FIRST NAMED INVENTOR ATTORNEY DOCKET NO APPLICATION NO. **FILING DATE** 09/460,007 HARPER, JR. D BERG-2462/C 12/13/99 **EXAMINER** MMC2/1107 JONATHAN M WALDMAN ESQ PAPER NUMBER **ART UNIT** WOODCOCK WASHBURN KURTZ MACKIEWICZ & NORRIS LLP ONE LIBERTY PLACE 46TH FLOOR 2833 PHILADELPHIA PA 19103 DATE WAILED: 11/07/01

Office Action Summary

DETAILED ACTION

FIG. 1

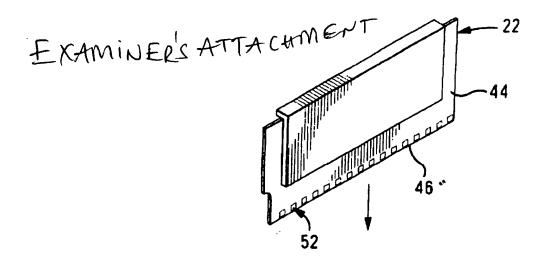
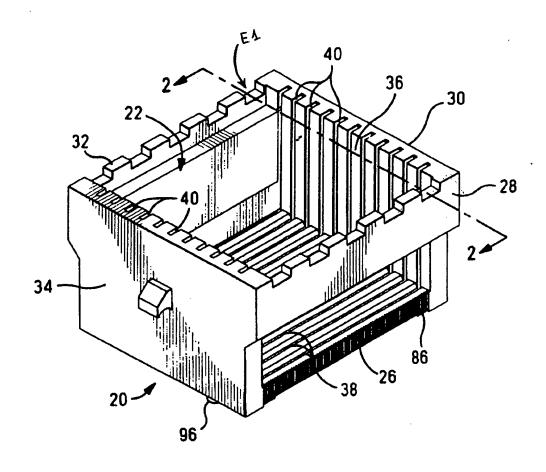
Walker discloses in Figure 1, an electrical connector housing (20) comprising a notch (E1) located only at location furthest from neutral point of the housing, the notch extending through a distal end of the peripheral wall from an inner face to an outer face.

Although Walker does not specifically disclose the slot (E1) is for the purpose of preventing warpage problem of the housing caused by thermal cycling. The structure, disclosed by Walker, would inherently obtain the advantage of the slot being presents in the housing. Thus, it has a capable of preventing warpage of the housing.
